**BMW Motorrad
USA**

Service Information Bulletin

****Technical Campaign****

Subject: Retrofitting Timing Chain Guide

chain guide installed (1)

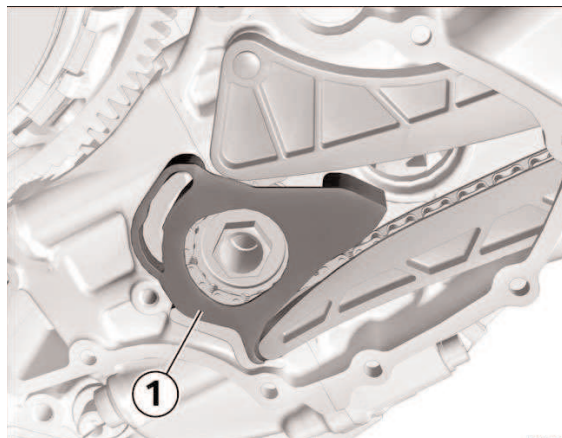
Details: BMW Motorrad has ascertained that on engines that have reached high mileage, the timing chain can stretch due to normal wear. In isolated cases, this can result in the timing chain slipping over the crankshaft gear before hydraulic pressure can build up in the chain tensioner when the engine is being started. The outcome can be damage to the valve train.

Aftersales Solution: When a motorcycle affected by this Technical Campaign is brought in for its next BMW service, it is to be checked, and if needed, the chain guide is to be retrofitted. See work item 11 11 515 on the latest RSD (Repair and Service Data BMW Motorrad) DVD for a description of the procedure for installing the chain guide.

Production Solution: A chain guide designed to prevent the timing chain from slipping has been installed as of December 2010. At the time of this production update, the check for chain guide (and installation if needed) was added to the maintenance interval during a valve check.
